Project	IEEE 802.16 Broadband Wireless Access Working Group < http://ieee802.org/16 >	
Title	Comment on Pilot Allocation for 5,6,7 and 8 BS Antennas	
Date Submitted	2004-11-11	
Source:	Wen Tong, Jianglei Ma, Peiyong Zhu, Ming Jia, Dongsheng Yu, Hua Xu, Mo-Han Fong, Hang Zhang, Brian Johnson Nortel Networks 3500 Carling Avenue Ottawa, ON. K2H 8E9 CANADA	Voice: (613)-763-1315 Fax: (613)-765-7723 wentong@nortelnetworks.com
Re:	Response to Sponsor Ballot call for comment	
Abstract	Propose Scattered Pilot Allocation for 5,6,7 and 8 BS Antennas	
Purpose	Comment on Scattered Pilot Allocation for 5,6,7 and 8 BS Antennas	
Notice	This document has been prepared to assist IEEE 802.16. It is offered as a basis for discussion and is not binding on the contributing individual(s) or organization(s). The material in this document is subject to change in form and content after further study. The contributor(s) reserve(s) the right to add, amend or withdraw material contained herein.

Comment on Pilot Allocation for 5,6,7 and 8 BS Antennas

Figure 1 scattered pilot pattern for maximum 8 transmit MIMO

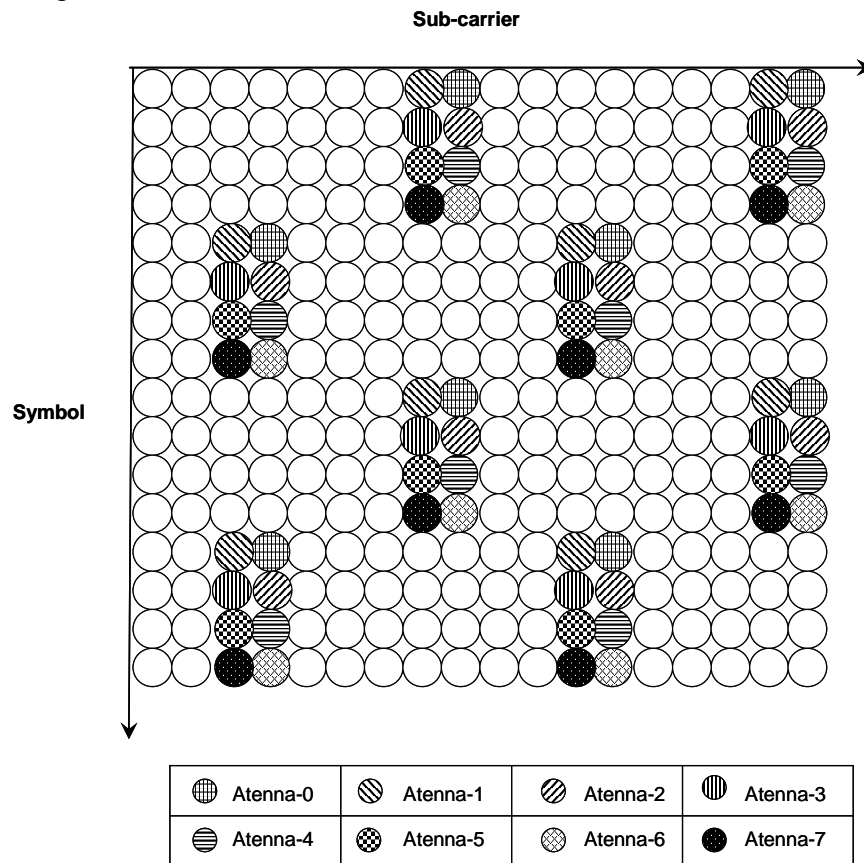
Contribution IEEE C802.16e-04/532 (comment 1527) proposes scattered pilot pattern for 5,6,7, and 8 DL transmit at BS. In this contribution, we propose to use single scattered pilots to support 5,6,7 and 8 antenna MIMO transmission in optional FUSC and optional AMC sub-channel.

The proposed a single pilot pattern is based on the larger coherent time span support for the slow mobility application as shown in Figure 1.
